UNITED STATES PATENT AND TRADEMARK OFFICE

APPLICATION NO.	FILING DATE	FIRST NAMED INVENTOR	ATTORNEY DOCKET NO.	CONFIRMATION NO.
10/791,750	03/04/2004	Kenji Takase	0951-0133P	5270
2292	7590	01/06/2006	EXAMINER	
BIRCH STEWART KOLASCH & BIRCH			HO, TU TU V	
PO BOX 747				
FALLS CHURCH, VA 22040-0747			ART UNIT	PAPER NUMBER
			2818

Office Action Summary	Application No.	Applicant(s)	
	10/791,750	TAKASE, KENJI	
	Examiner Tu-Tu Ho	Art Unit 2818

DETAILED ACTION

FIG. 6

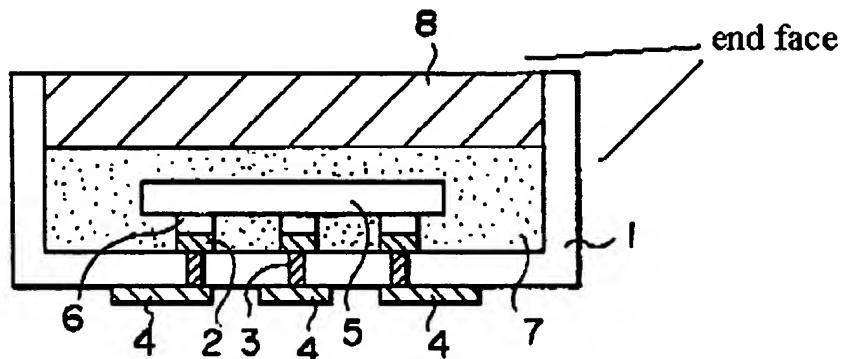
With respect to the **argument** that the reference does not disclose one or more electrically conductive patterns be formed at one or more end faces of a substrate (Remark filed 10/27/2005, Page 9), it is respectfully pointed out that the reference does disclose one or more

electrically conductive patterns be formed at one or more end faces of a substrate. See Figs. 6 and 7, reproduced below or next page.

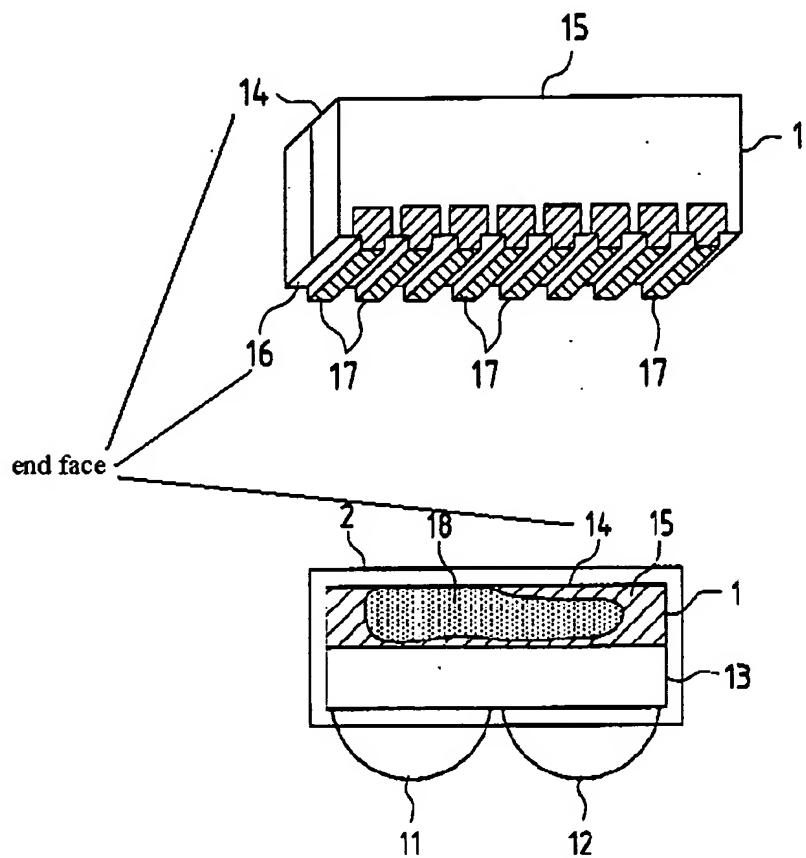
end face 1. With respect to the **argument** that a top face or a bottom face is not an end face (Remark filed 10/27/2005, Page 9), it is respectfully pointed out that a top face or a bottom face of an element can be considered an end face. The top face or the bottom face of the element defines an end of the element, thus qualifying either the top face or the bottom face of the

element as an end face. The broad interpretation of the term "end face" is reinforced by the fact that Applicant has appeared to indicate such usage. See Figs. 3 and 4 of the present invention, reproduced below or next page, for instances of the usage of "end face". While limitations from the specification shall not be read into the claims during prosecution, claim terminologies are still interpreted in light of the specification.

FIG.1

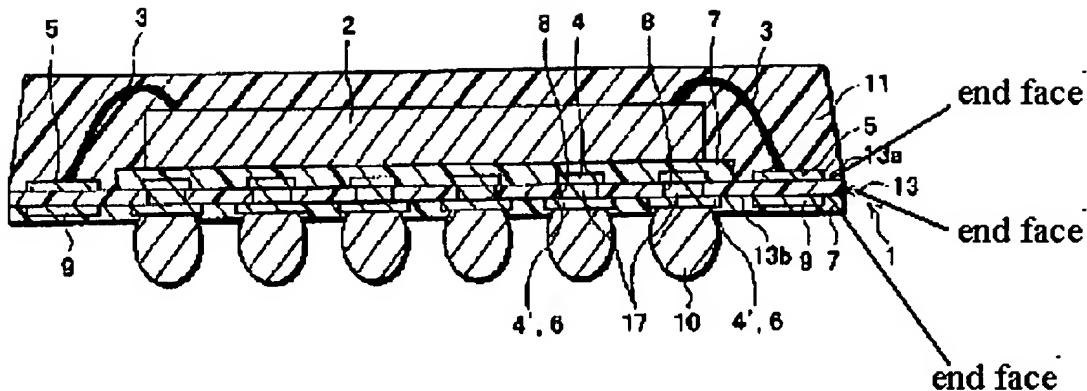
With respect to the **argument** that substrate 1 has nothing on its end faces as required by claim 1 (Remark filed 10/27/2005, Page 9), it is respectfully pointed out that substrate 1 includes one or more electrically conductive patterns (4', 4) on its end faces as required by claim 1.

As detailed above, wiring substrate 1 comprises at least solder resist 7 and insulating substrate 13. The insulating substrate 13, thus the wiring substrate 1 because said wiring substrate 1 comprises said insulating substrate 13, or simply substrate, has a bottom face and a top face that can be considered an end face, and the electrically conductive patterns (4', 4) are formed on its end faces, thus meeting the claimed limitation. See Fig. 1, reproduced below or next page.
